1370 STEWART ST

PRIORITIES & BOARD RECOMMENDATIONS

After visiting the site, considering the analysis of the site and context provided by the proponents, and hearing public comment, the Design Review Board members provided the following siting and design guidance.

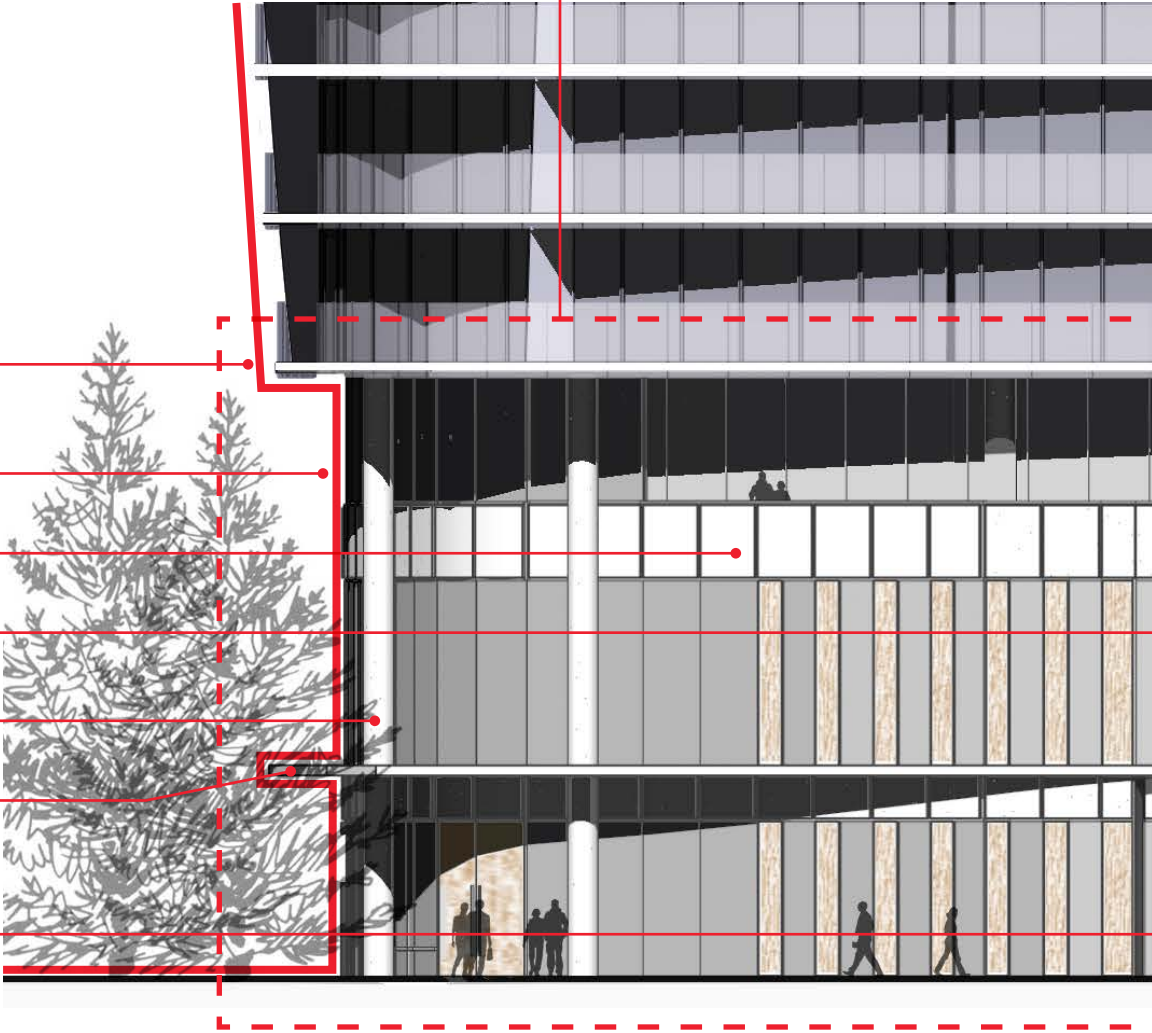
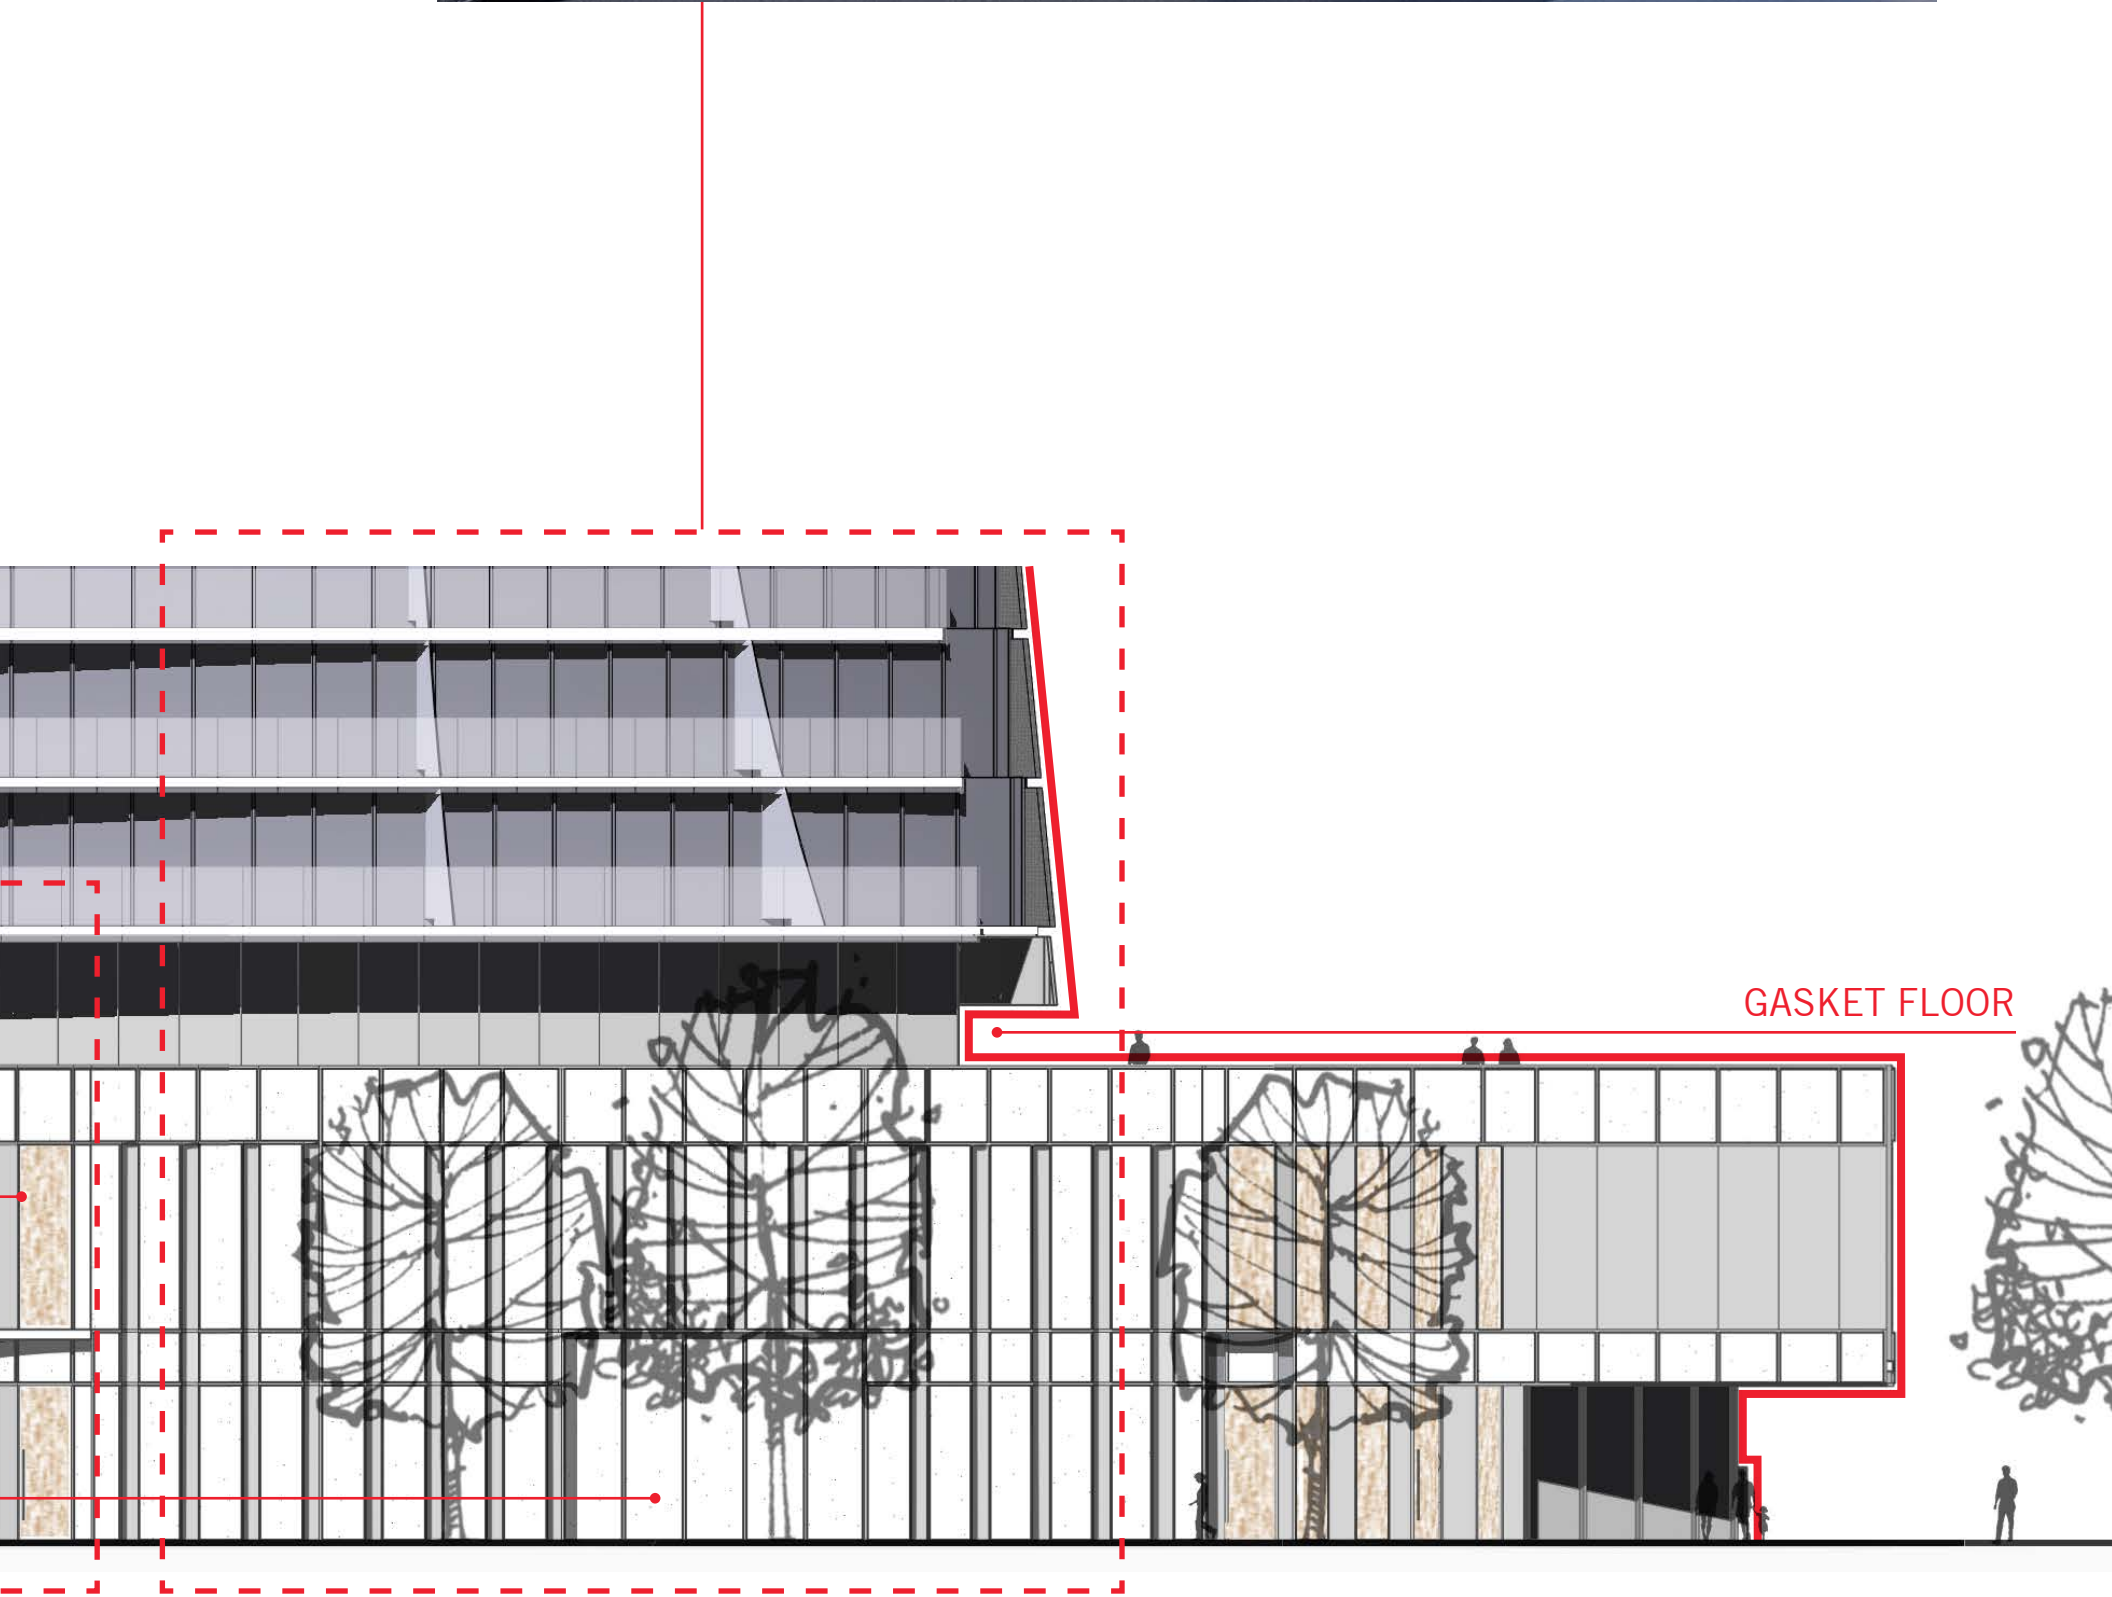
5B. The Board neither supported nor opposed the ‘glass box’ expression of the podium. The Board agreed that although there is no context precedent that would support this choice, the unique location at this unusual triangular site adjacent to I-5 would support a wide variety of solutions, including one not directly connected to context. (CS2-A, CS2-4, CS3-A-2)

5C. Regardless of the direction the podium design takes, the Board asked to see a clear design connection between the materiality of the base and the tower. The design should express a logical scheme for human scale elements in the pedestrian zones. (DC2-2, DC2-3)

SCALING ELEMENTS
Skin recess and material change differentiate podium from tower.

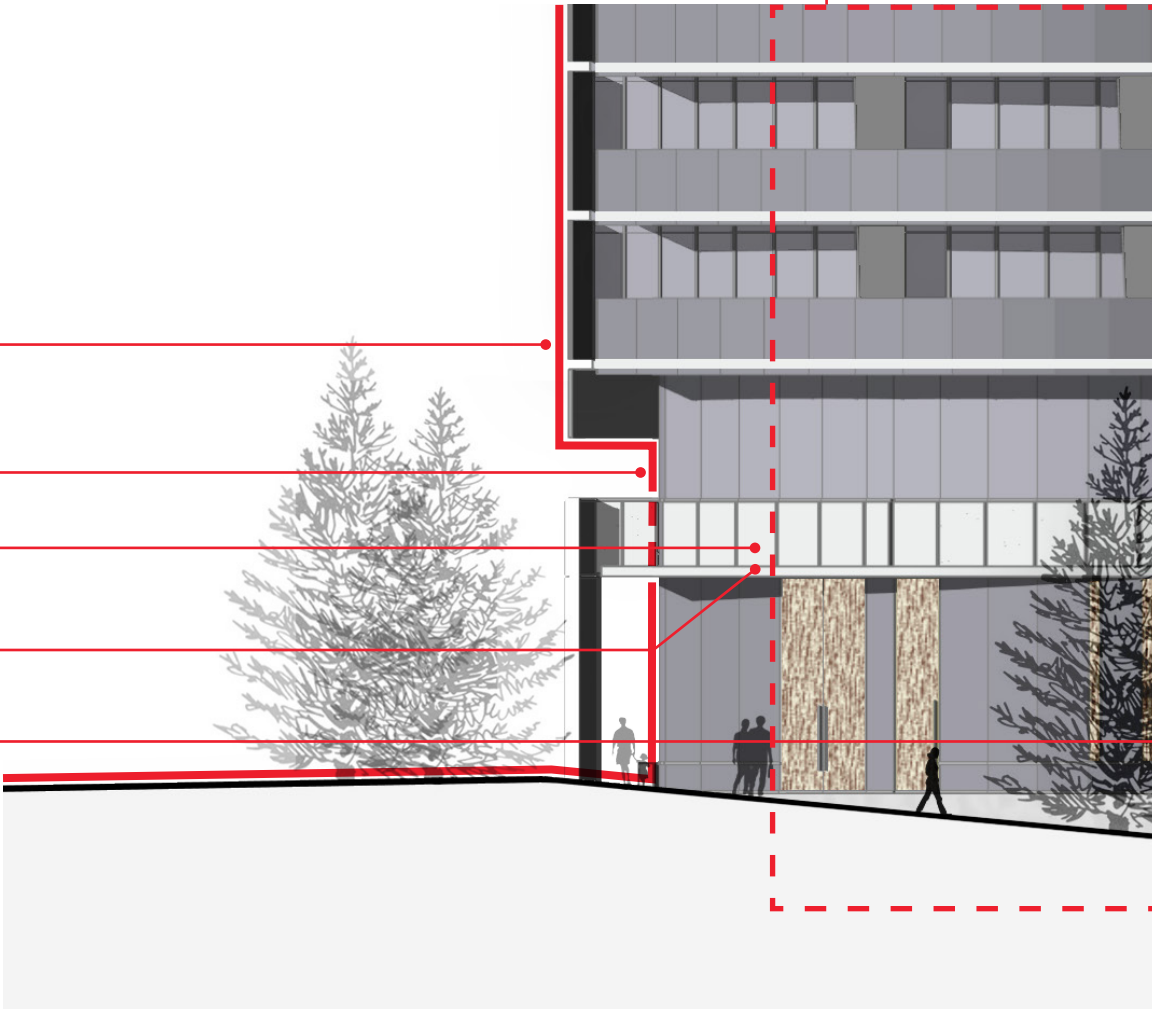
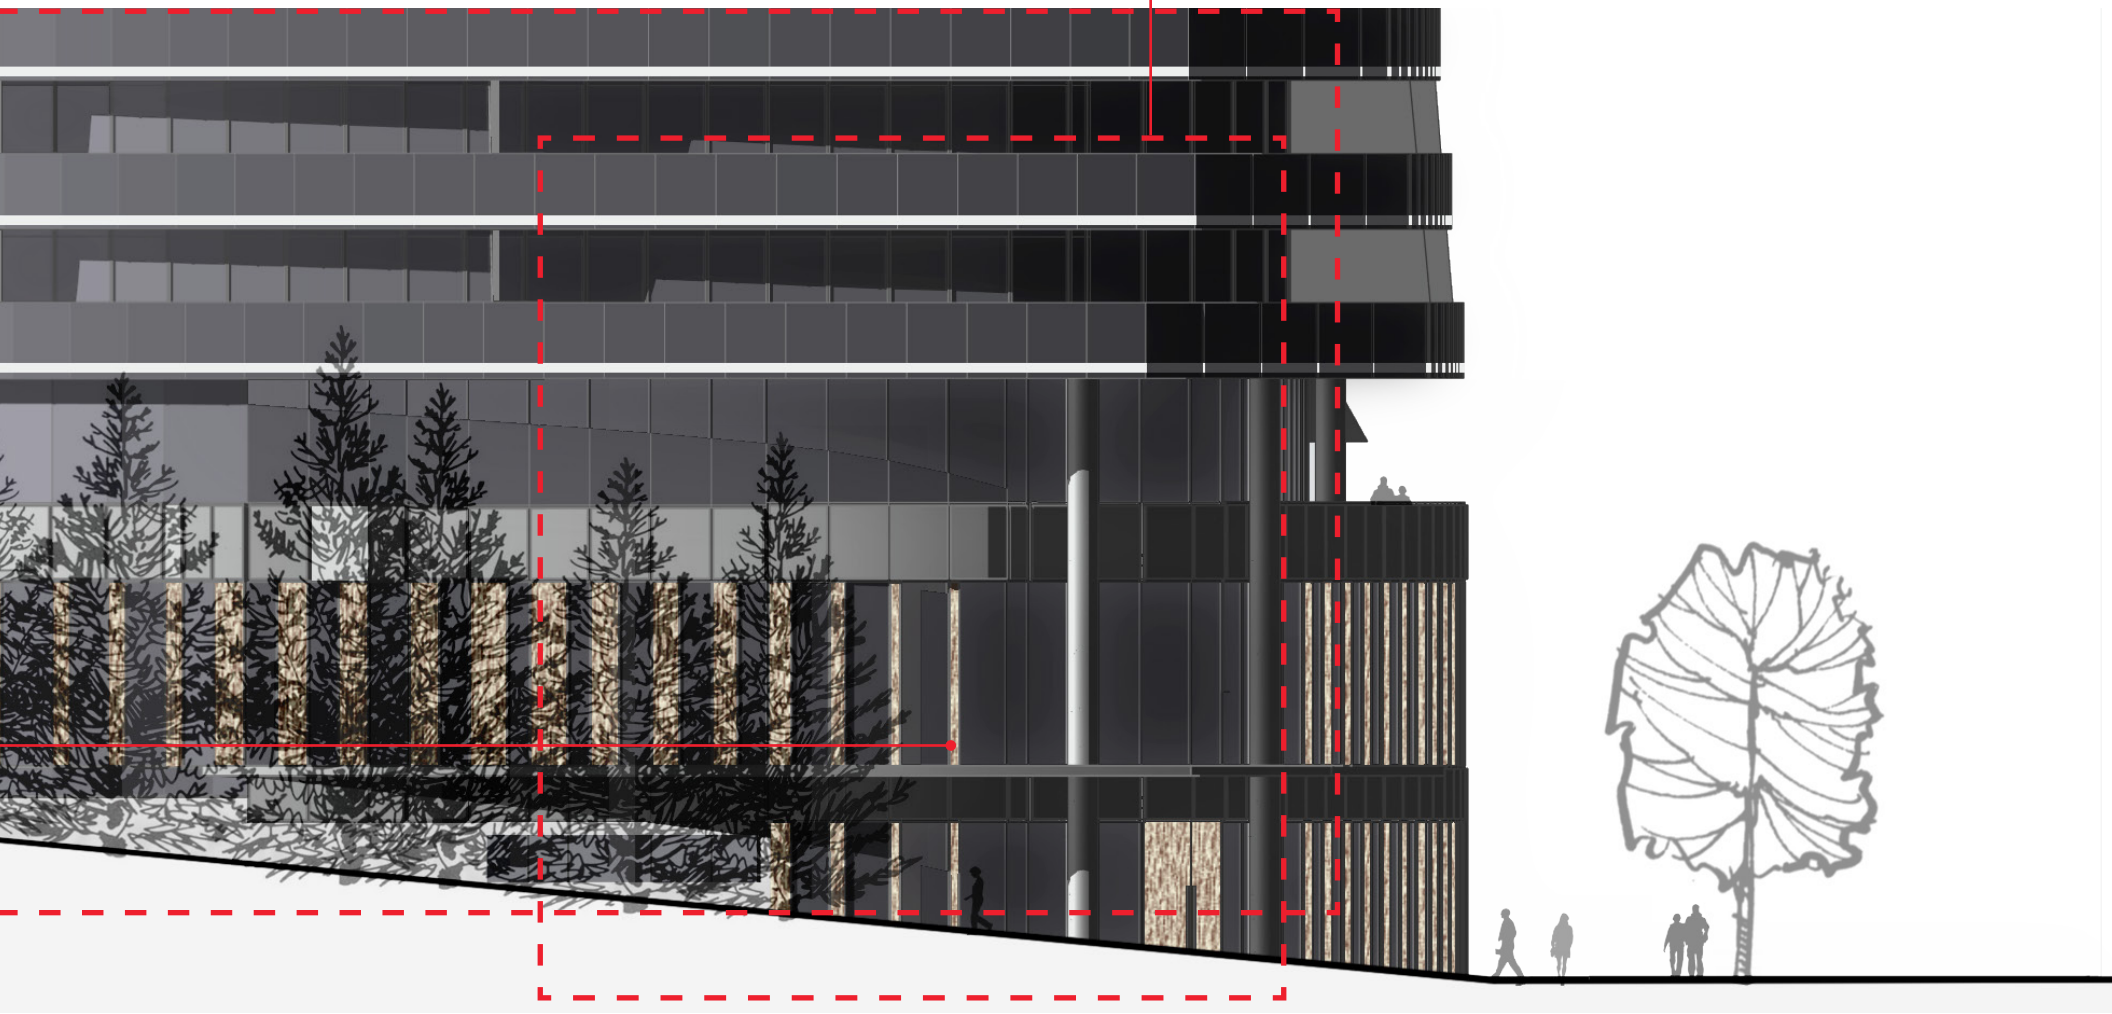
5B. The Board neither supported nor opposed the ‘glass box’ expression of the podium. The Board agreed that although there is no context precedent that would support this choice, the unique location at this unusual triangular site adjacent to I-5 would support a wide variety of solutions, including one not directly connected to context. (CS2-A, CS2-4, CS3-A-2)

5C. Regardless of the direction the podium design takes, the Board asked to see a clear design connection between the materiality of the base and the tower. The design should express a logical scheme for human scale elements in the pedestrian zones. (DC2-2, DC2-3)

SCALING ELEMENTS
Skin recess and material change
differentiate podium from tower.

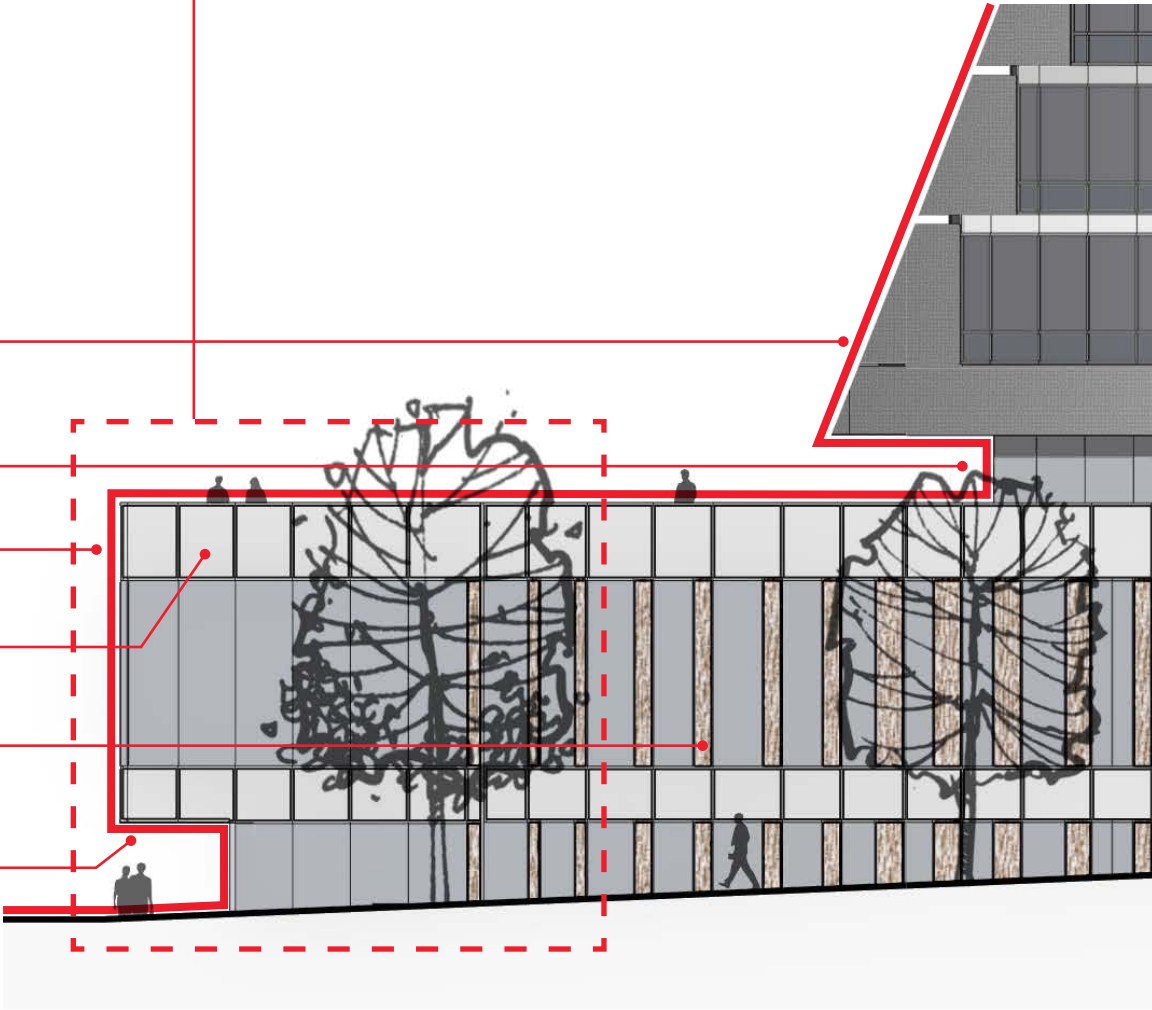
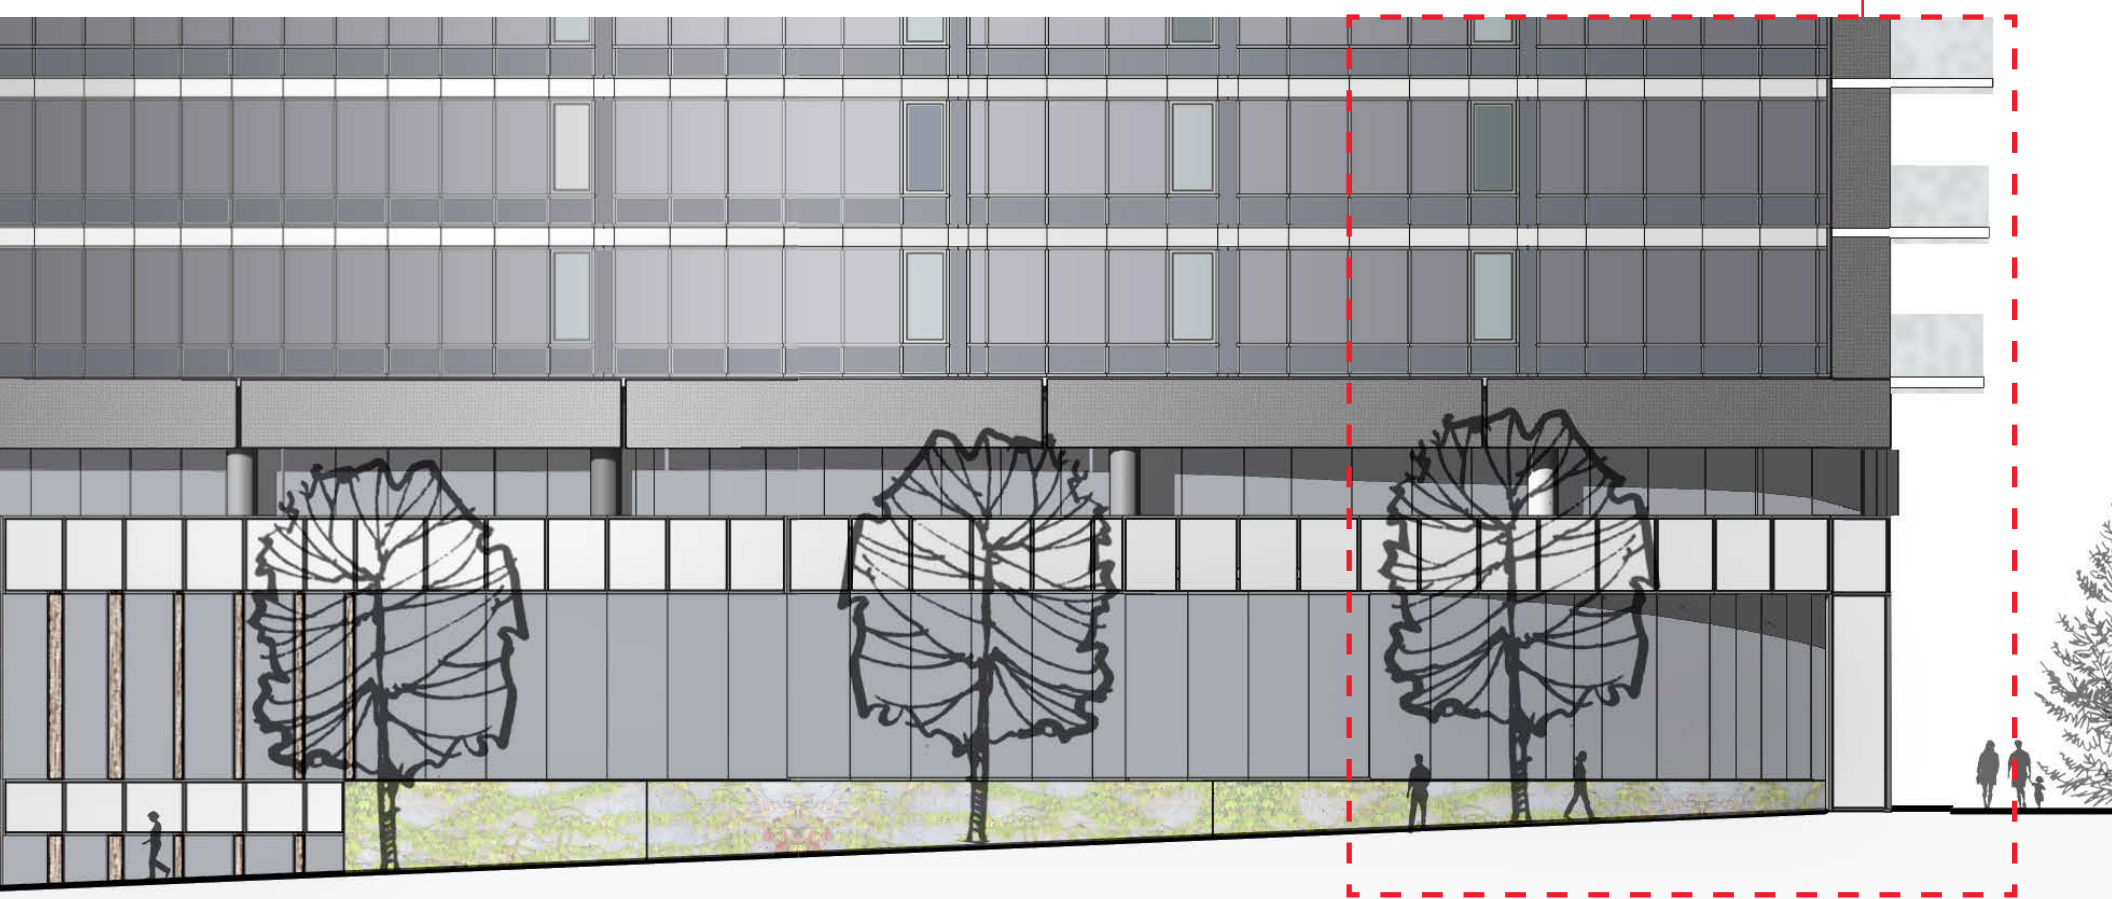
5B. The Board neither supported nor opposed the ‘glass box’ expression of the podium. The Board agreed that although there is no context precedent that would support this choice, the unique location at this unusual triangular site adjacent to I-5 would support a wide variety of solutions, including one not directly connected to context. (CS2-A, CS2-4, CS3-A-2)

5C. Regardless of the direction the podium design takes, the Board asked to see a clear design connection between the materiality of the base and the tower. The design should express a logical scheme for human scale elements in the pedestrian zones. (DC2-2, DC2-3)

SCALING ELEMENTS

Skin recess and material change differentiate podium from tower.
